### Five County Stadium - ADA Phase 2

Project No. RFB #25-070

#### **ADDENDUM 02**

**D200**

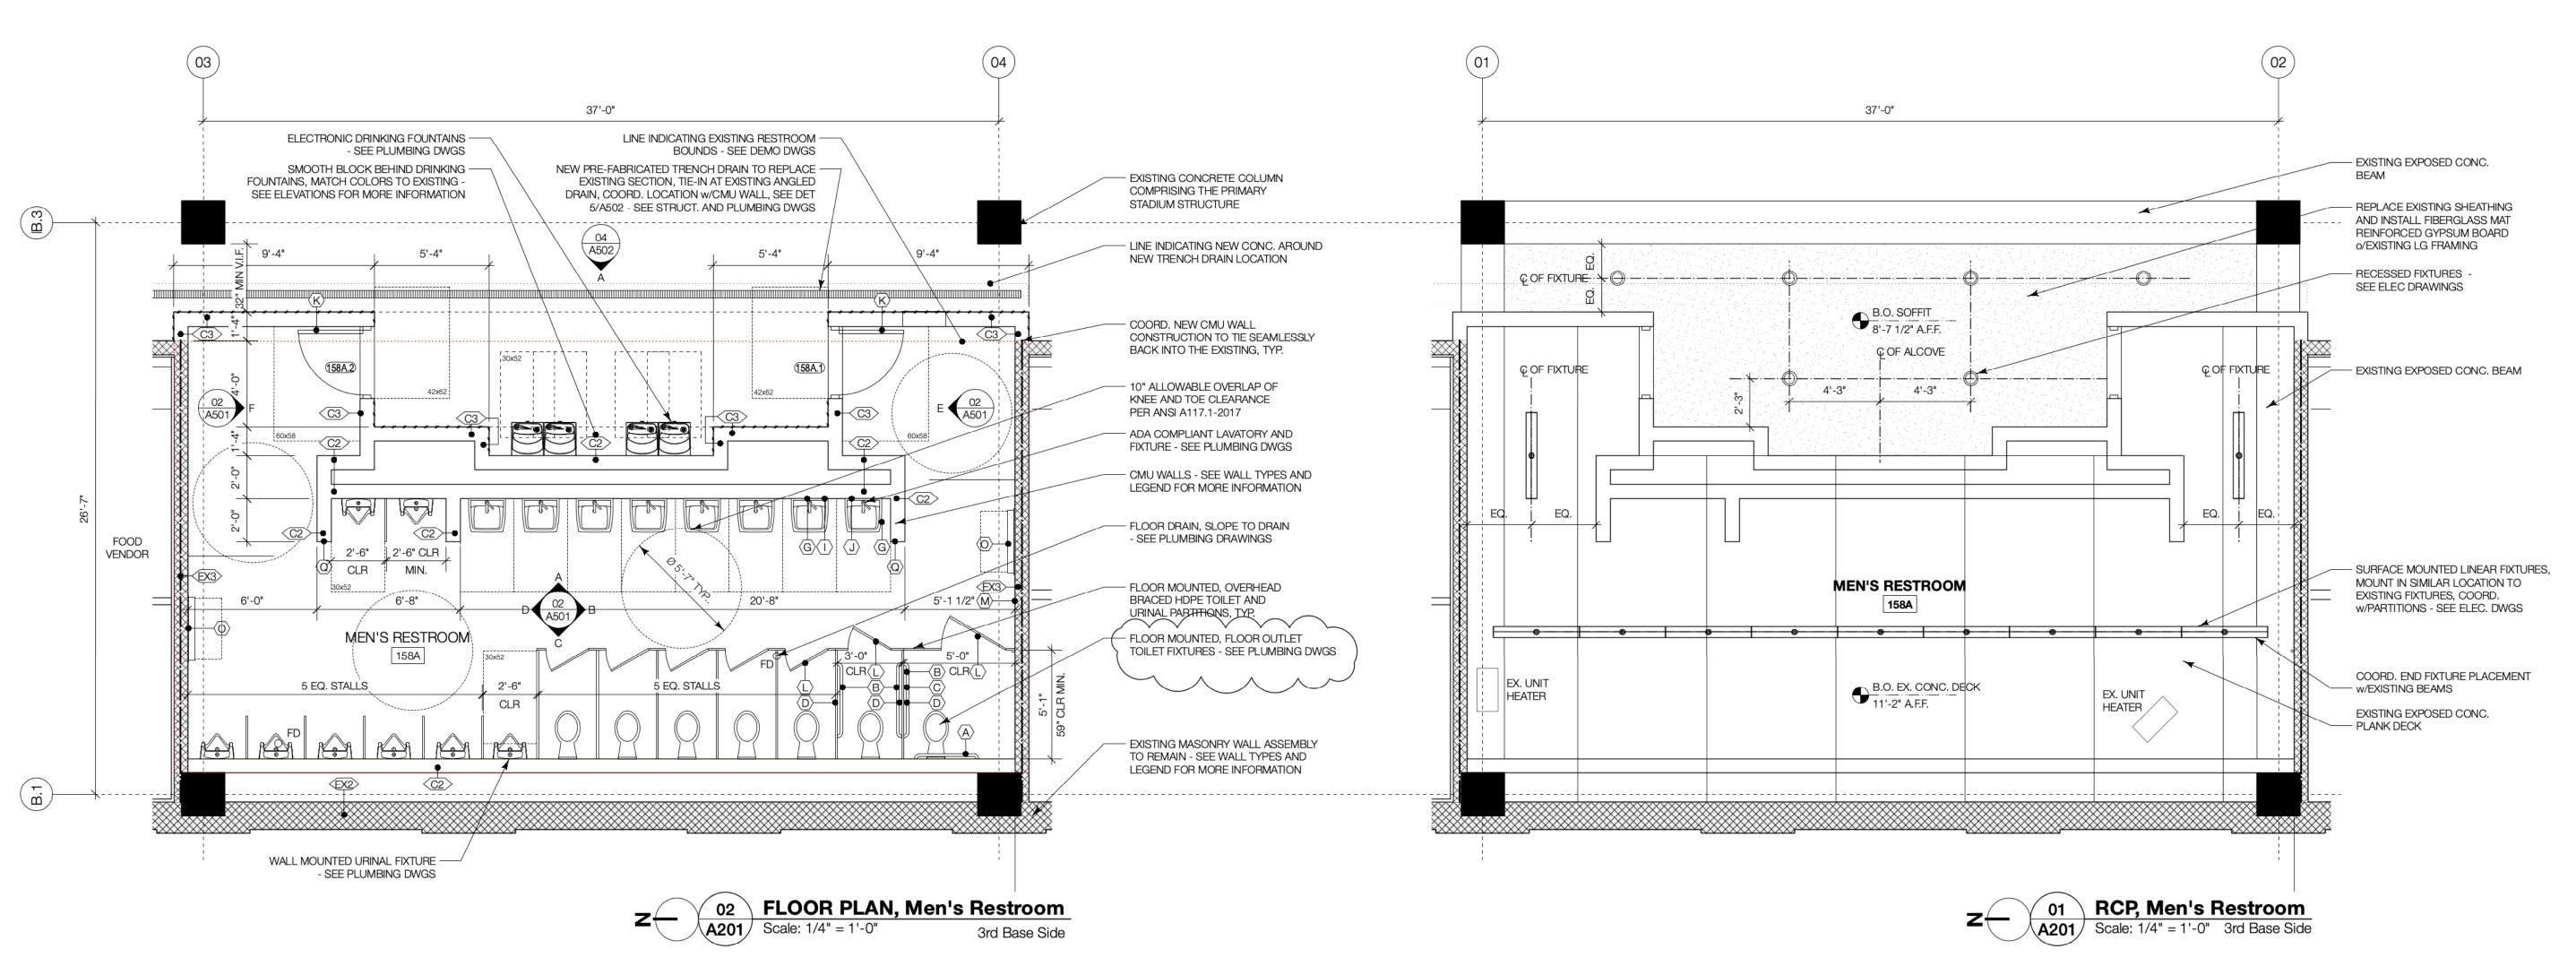
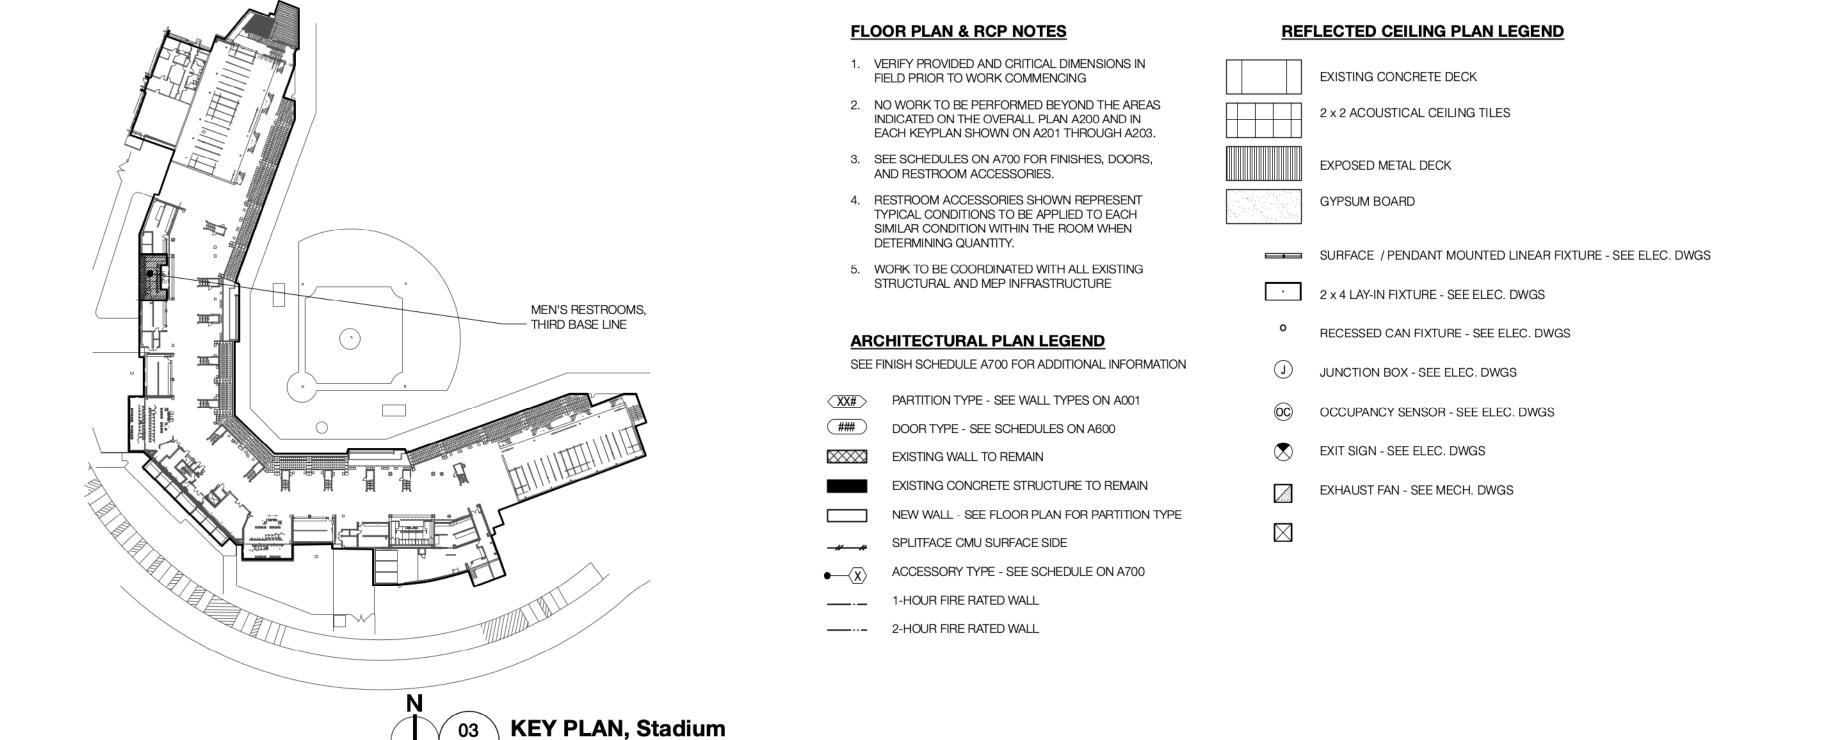
- D200 Demo Plan
  - General Notes, Existing Utilities Sections C, D and E
    - 1. Revise references from 'throughout the building' to 'throughout the work area.'

- 2. Revise reference from 'Civil Drawings' to 'Plumbing Drawings.' There are no civil drawings that are a part of this bid package.
- A201 Floor Plan

# **A201**

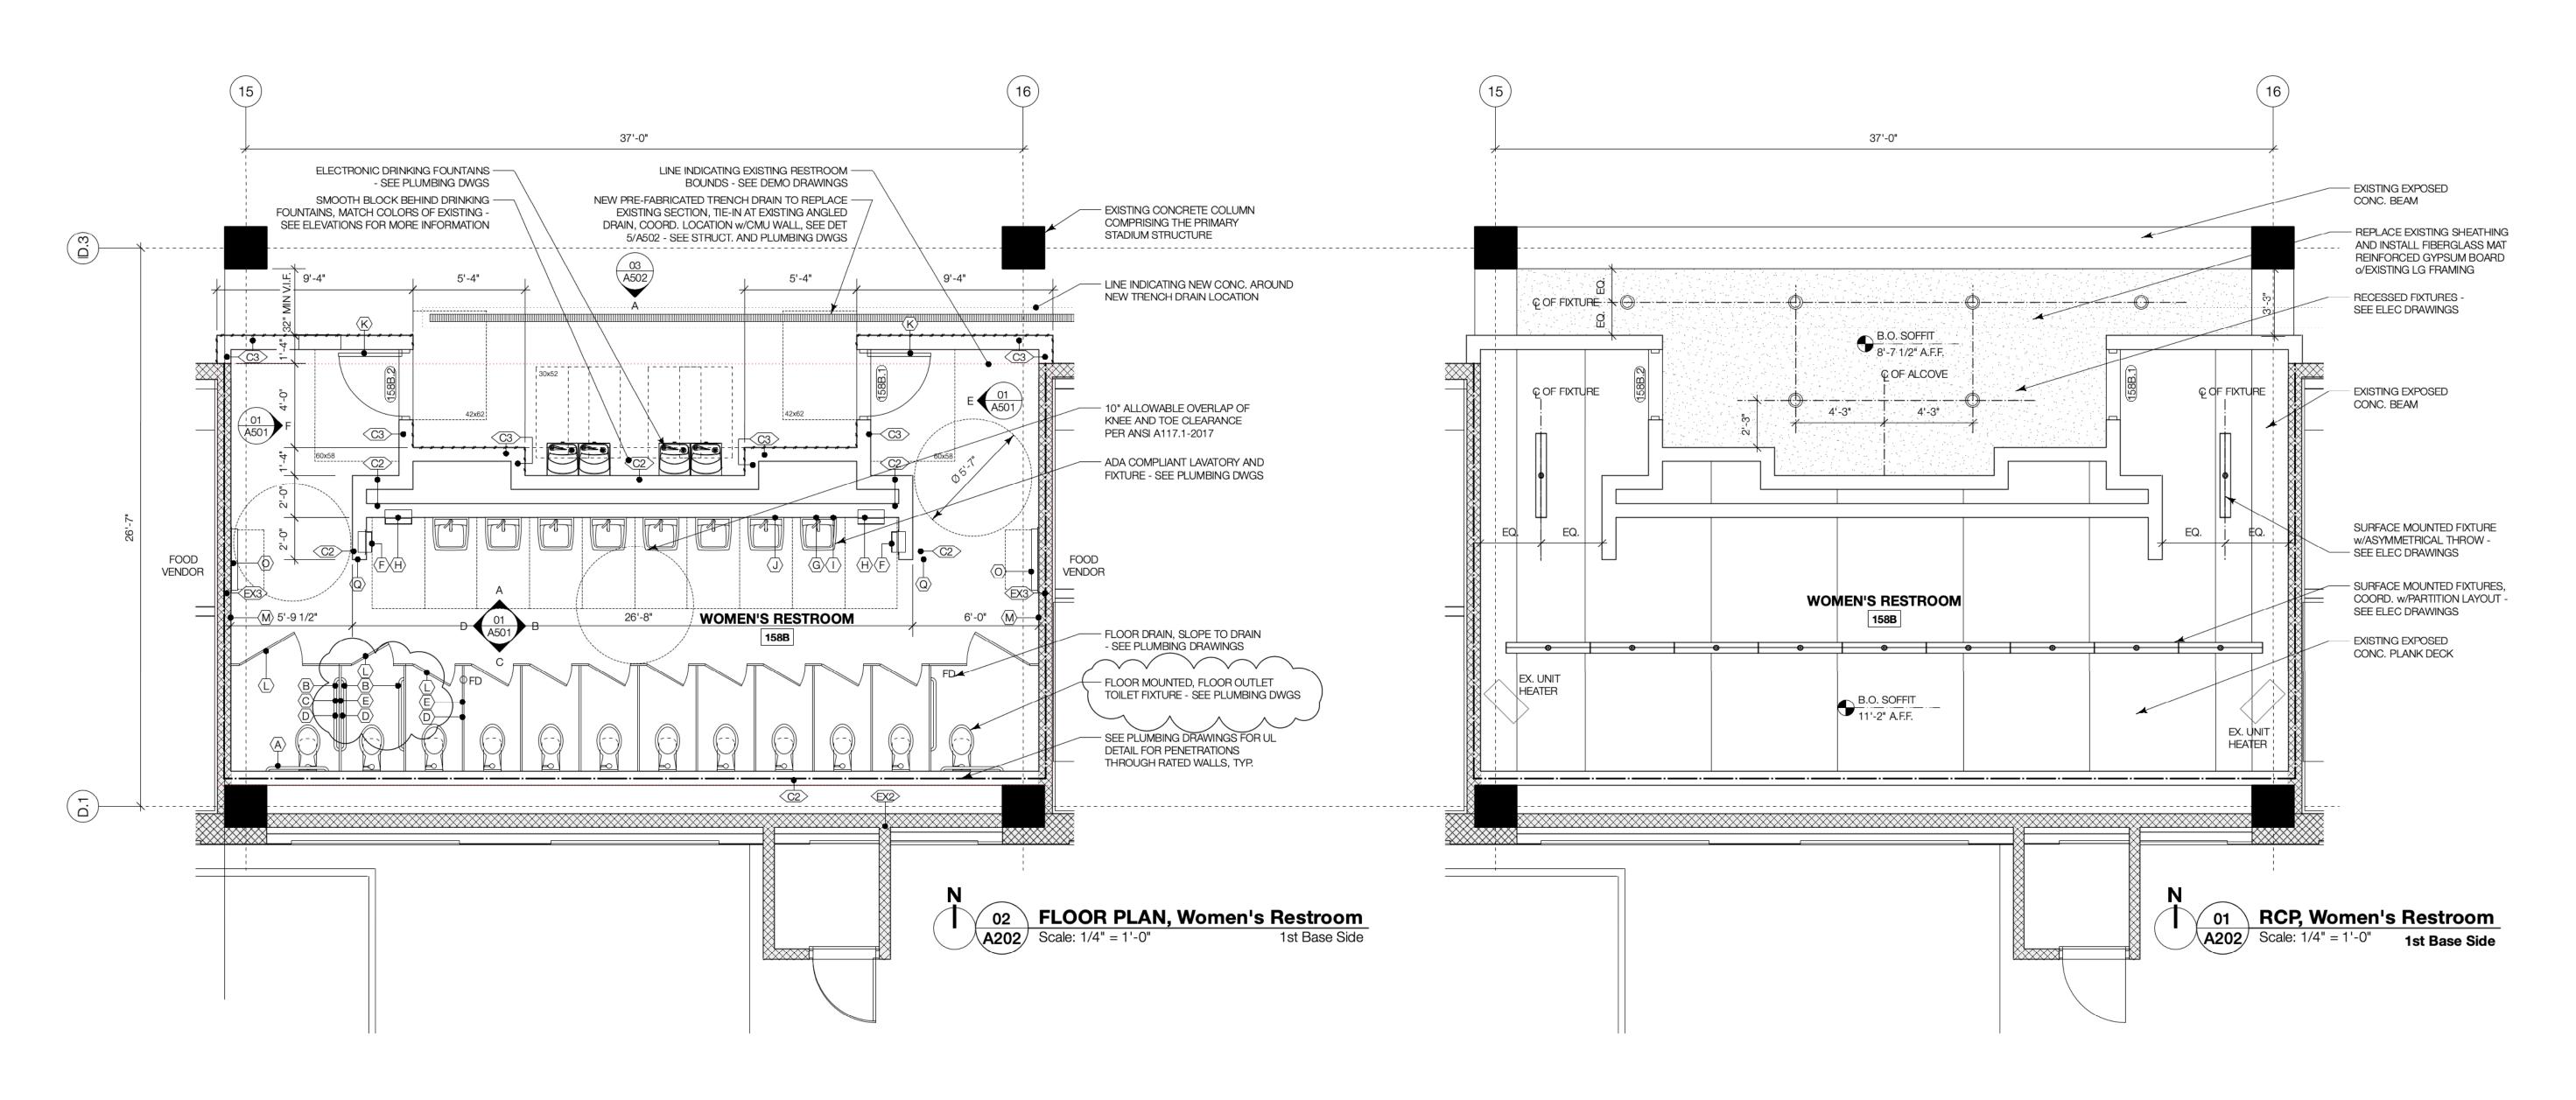
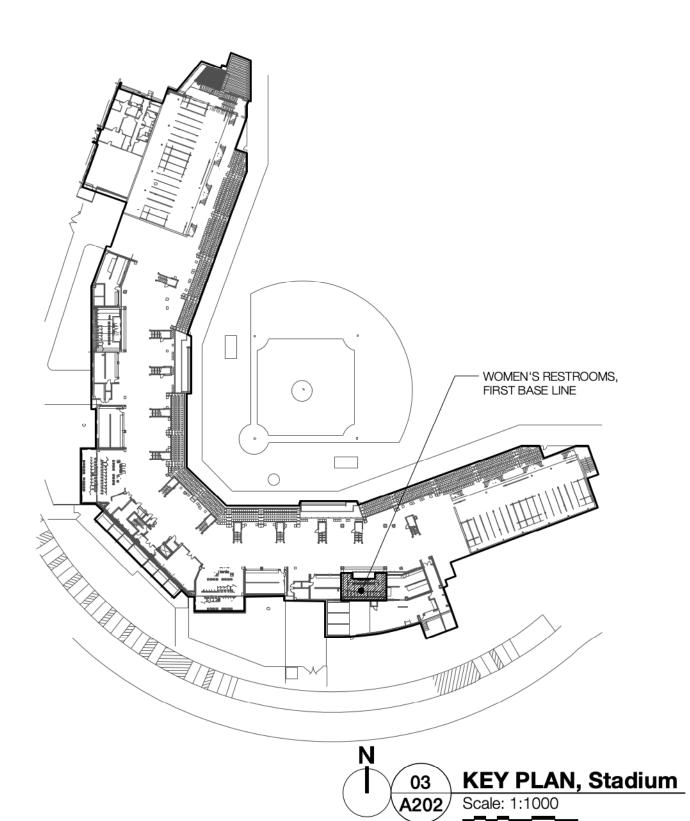
- Restroom plan 02/A201 toilet fixture callout was revised to read 'Floor mounted, floor outlet toilet fixtures - see plumbing dwgs.'
- A202 Floor Plan

**A202**

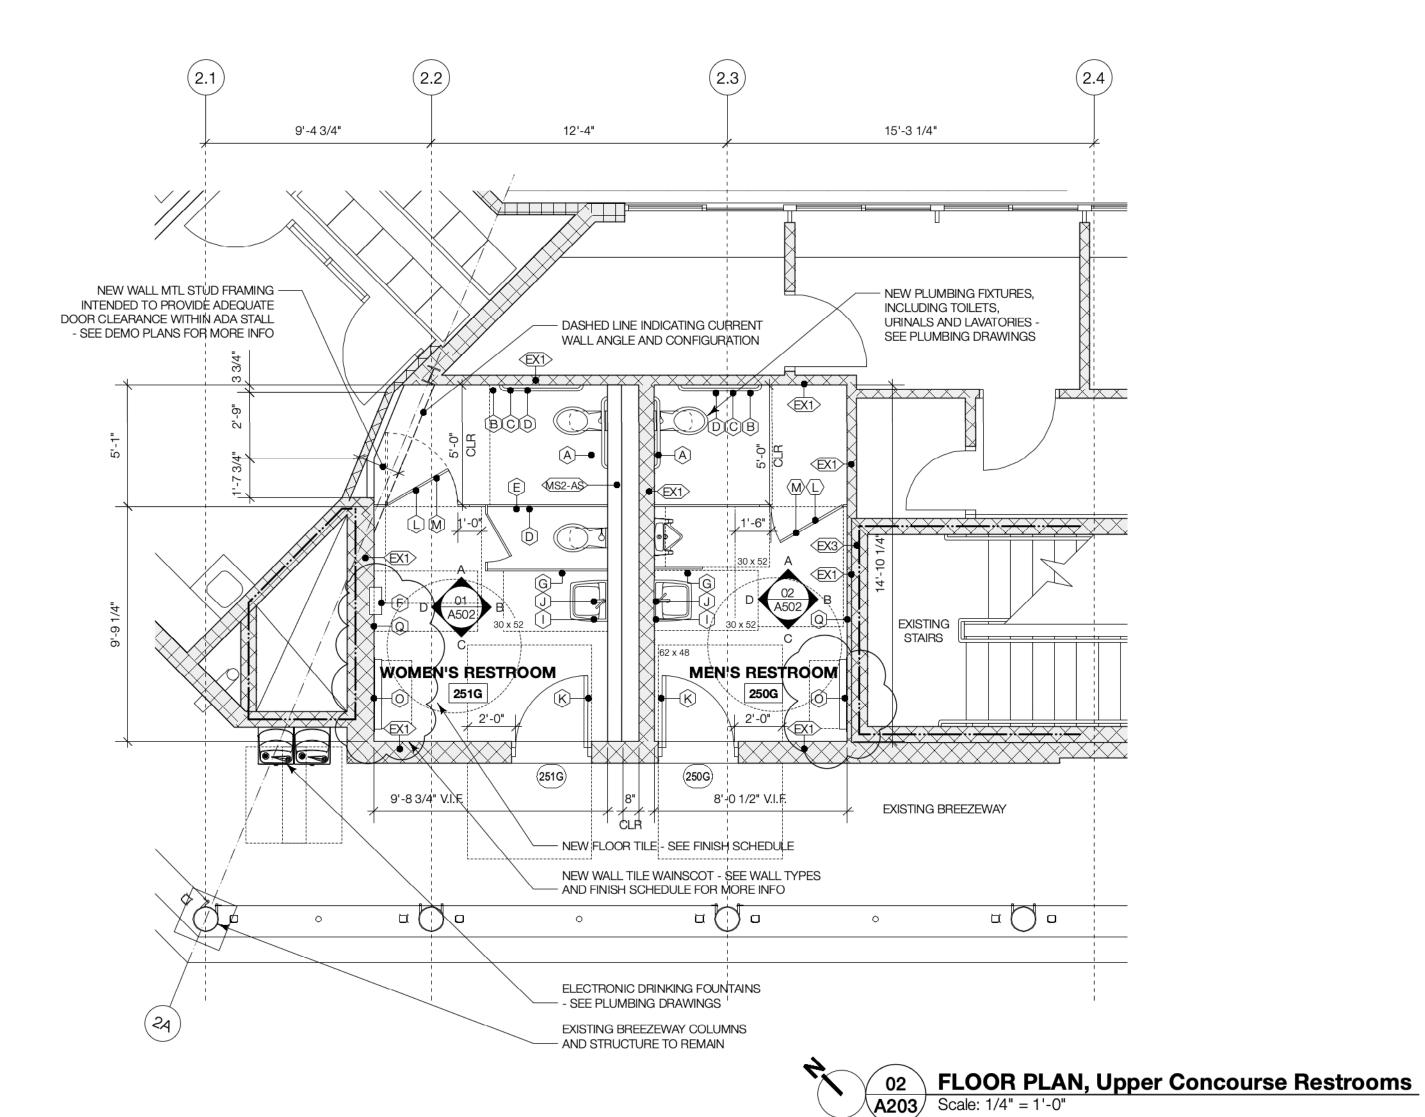
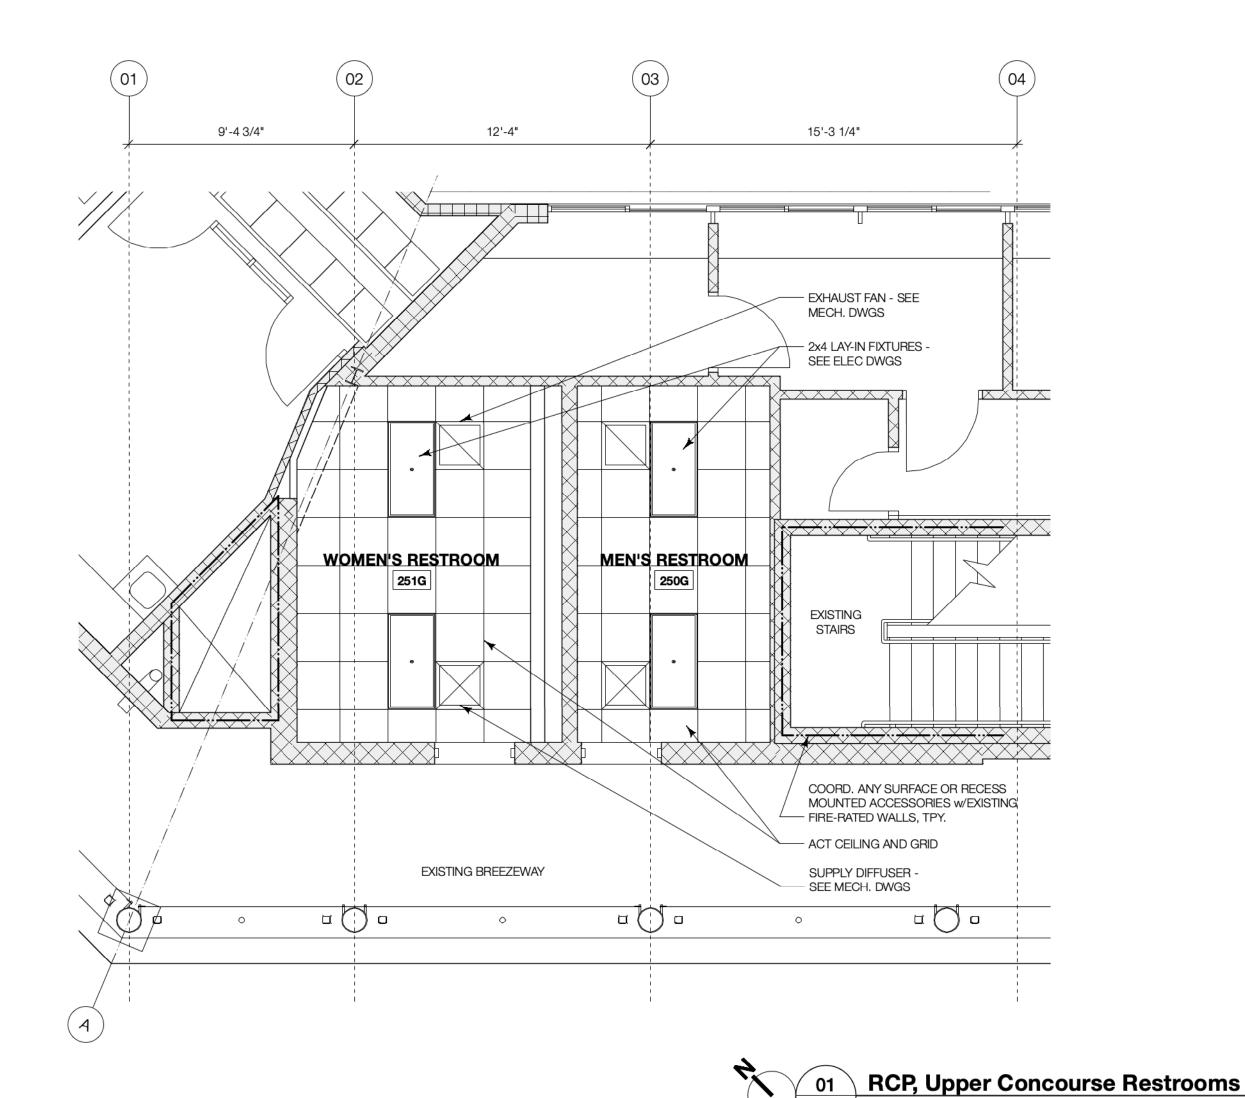
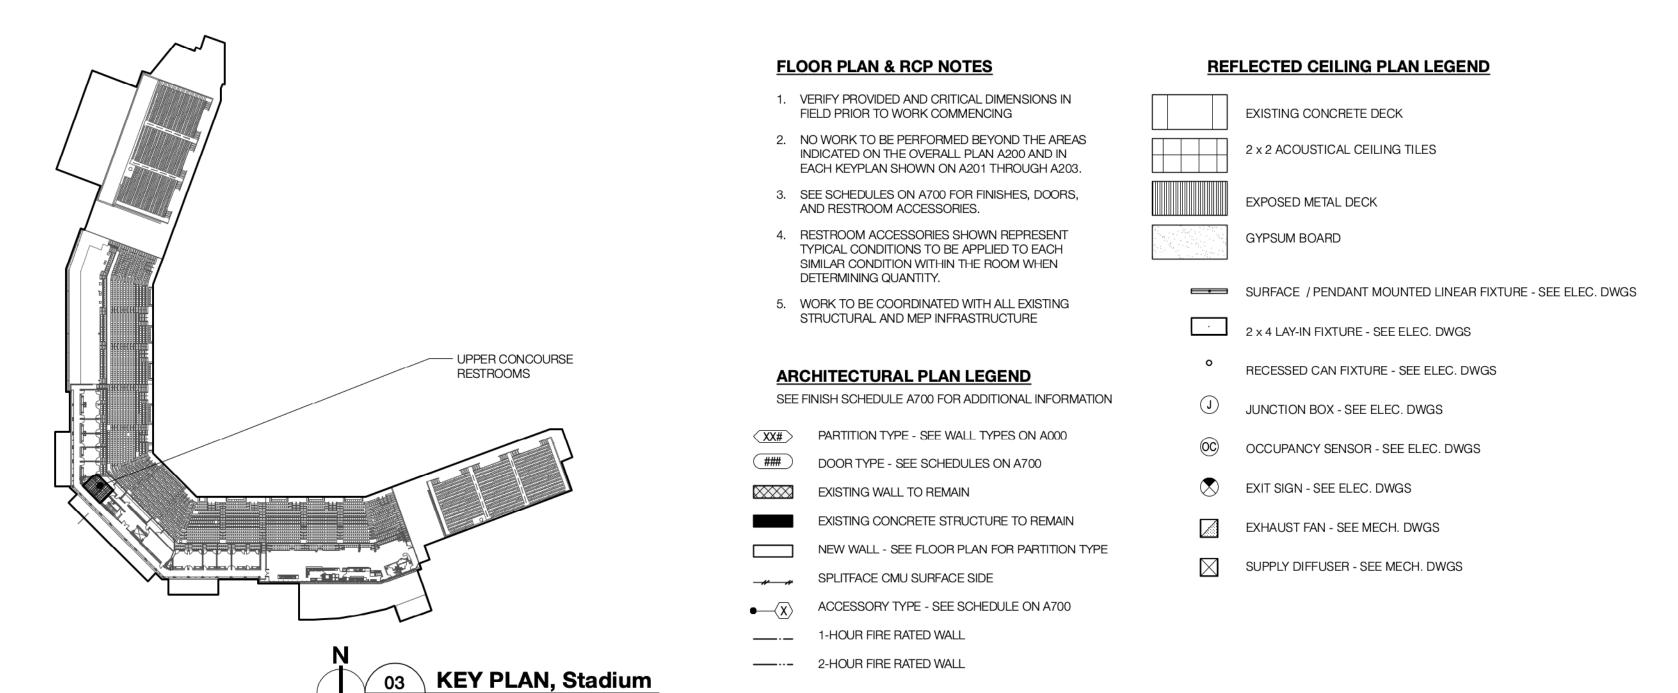
- Restroom plan 02/A202 was revised to properly indicate the location of sanitary napkin disposal 'E' instead of dispensers 'F' in the Accessible, Ambulatory and Typical restroom stalls.

- The accessories indicated in the stalls are shown as typical conditions and should be applied to all similar conditions found in the restroom.
  - Restroom plan 02/A202 toilet fixture callout was revised to read 'Floor mounted, floor outlet toilet fixtures - see plumbing dwgs.'
